**PLANNING COMMISSION  
RESOLUTION NO. LP24-0001**

**A RESOLUTION OF THE CITY OF WILSONVILLE PLANNING COMMISSION RECOMMENDING THE WILSONVILLE CITY COUNCIL AMEND THE TEXT OF THE DEVELOPMENT CODE TO MAKE MINOR MODIFICATIONS TO THE COFFEE CREEK INDUSTRIAL DESIGN OVERLAY DISTRICT STANDARDS.**

<b>Meeting Date:</b> February 14, 2024		<b>Subject:</b> Coffee Creek Code Amendments	
		<b>Staff Members:</b> Cindy Luxhoj AICP, Associate Planner	
		<b>Department:</b> Community Development	
<b>Action Required</b>		<b>Advisory Board/Commission Recommendation</b>	
<input type="checkbox"/> Motion <input type="checkbox"/> Public Hearing Date: <input type="checkbox"/> Ordinance 1 <sup>st</sup> Reading Date: <input type="checkbox"/> Ordinance 2 <sup>nd</sup> Reading Date: <input checked="" type="checkbox"/> Resolution <input type="checkbox"/> Information or Direction <input type="checkbox"/> Information Only <input type="checkbox"/> Council Direction <input type="checkbox"/> Consent Agenda		<input type="checkbox"/> Approval <input type="checkbox"/> Denial <input type="checkbox"/> None Forwarded <input checked="" type="checkbox"/> Not Applicable	
		<b>Comments:</b> N/A	
<b>Staff Recommendation:</b> A

# Table CC-3: Site Design Parcel Pedestrian Access

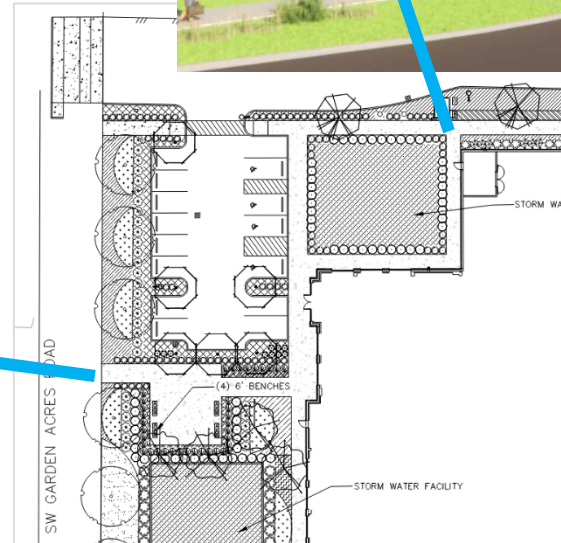
- Limit where 8-foot access width is required

Other access:  
Minimum meeting  
accessibility  
requirements

Primary access:  
8 ft minimum

# Table CC-3: Site Design

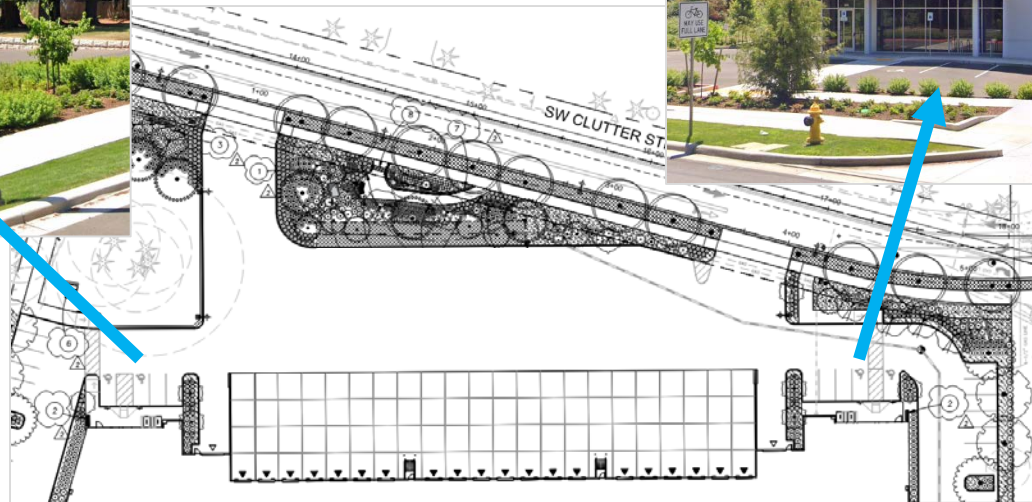
- Eliminate parking bay limit and allow some parking use for longer duration

# Table CC-3: Site Design Grading and Retaining Walls

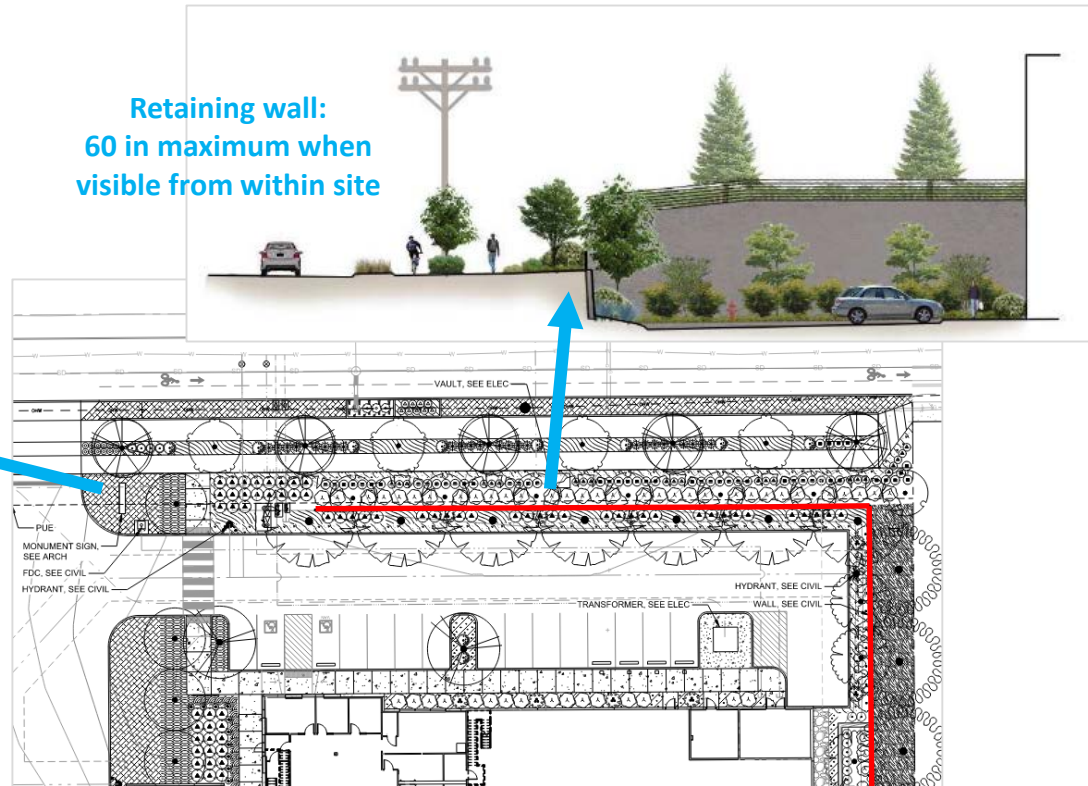
- Increase height of walls not visible from adjacent streets

**Retaining wall:  
48 in maximum when  
visible from street**

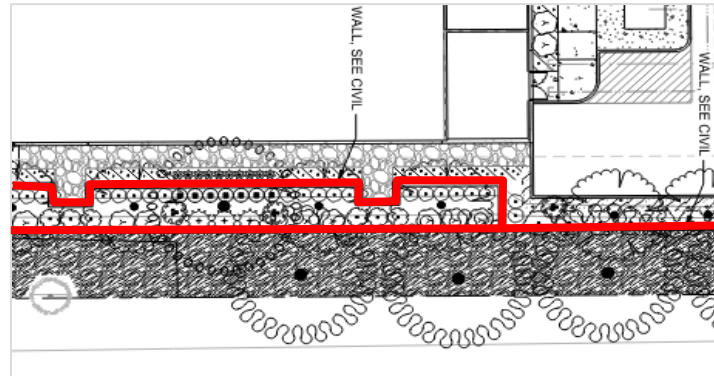
- Clarify meaning of “horizontal offset”

Tiered retaining wall with  
“horizontal offset” between  
lowest part and upper  
part(s) of wall

# Table CC-3: Site Design Parcel Pedestrian Access

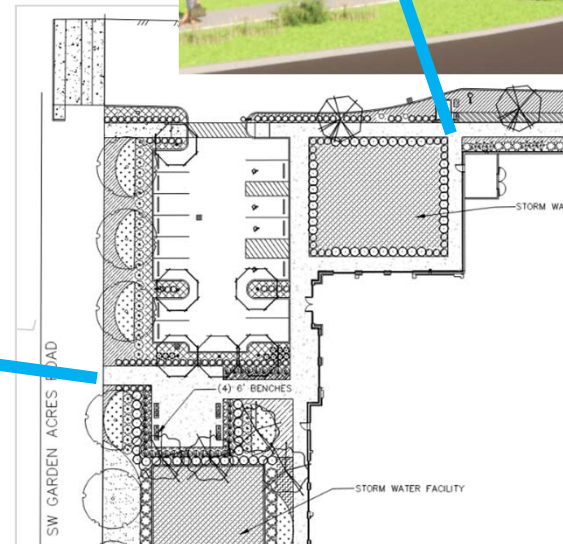
- Limit where 8-foot access width is required

# Table CC-3: Site Design Parking Location and Extent

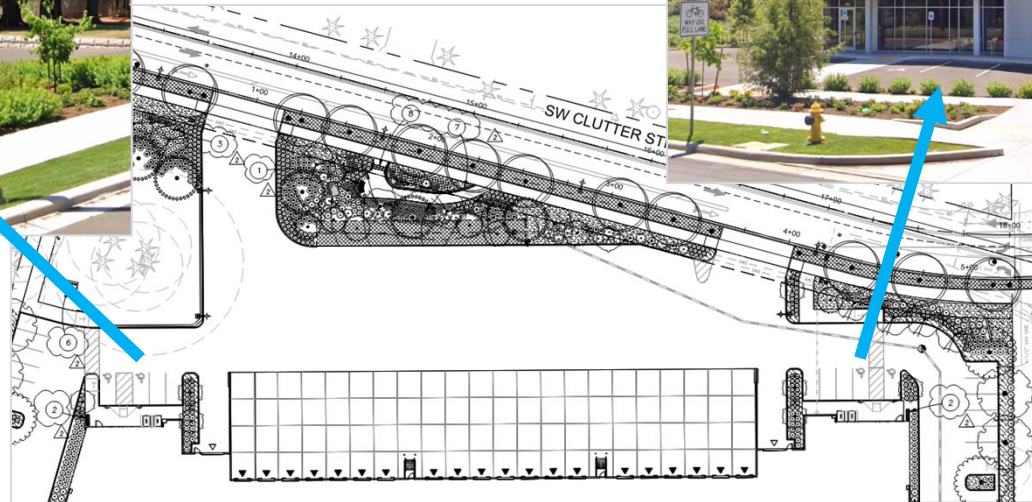
- Eliminate parking bay limit and allow some parking use for longer duration

# Table CC-3: Site Design Grading and Retaining Walls

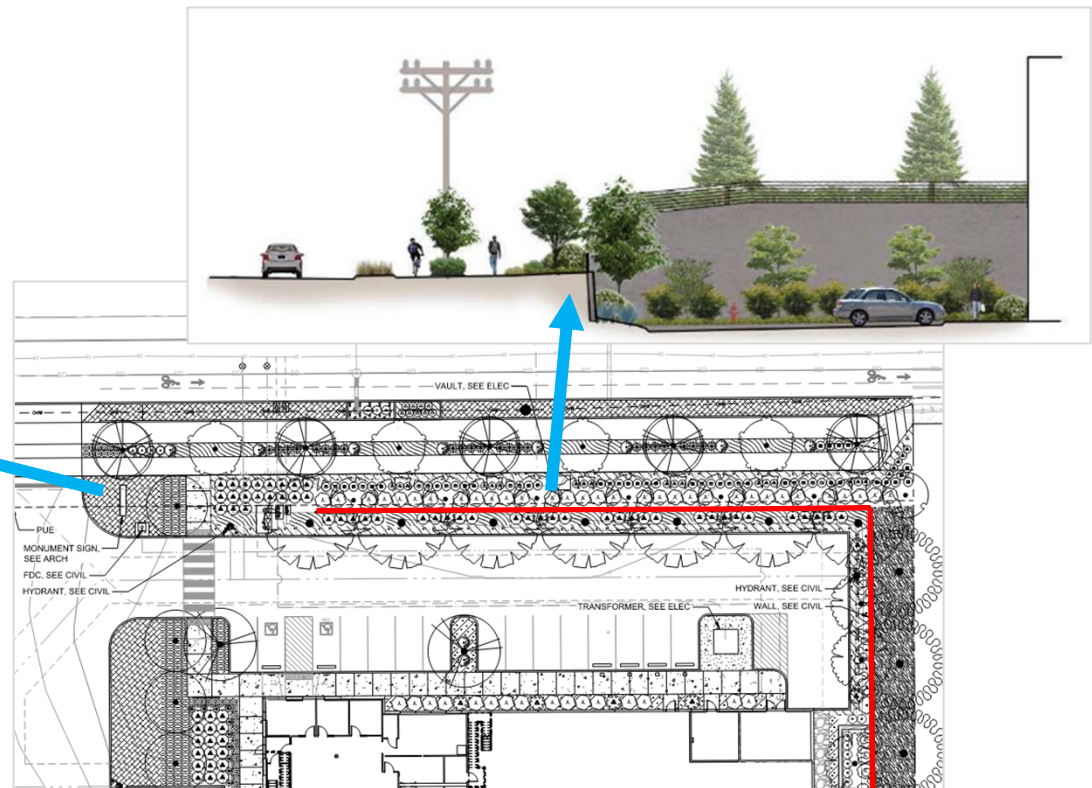
- Increase height of walls not visible from adjacent streets

# Table CC-3: Site Design Grading and Retaining Walls

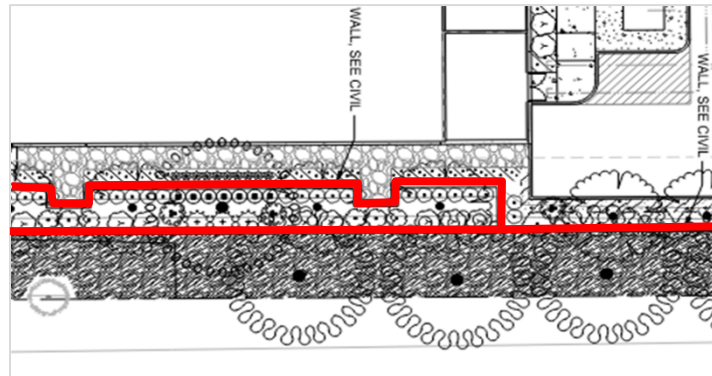
- Clarify meaning of “horizontal offset”
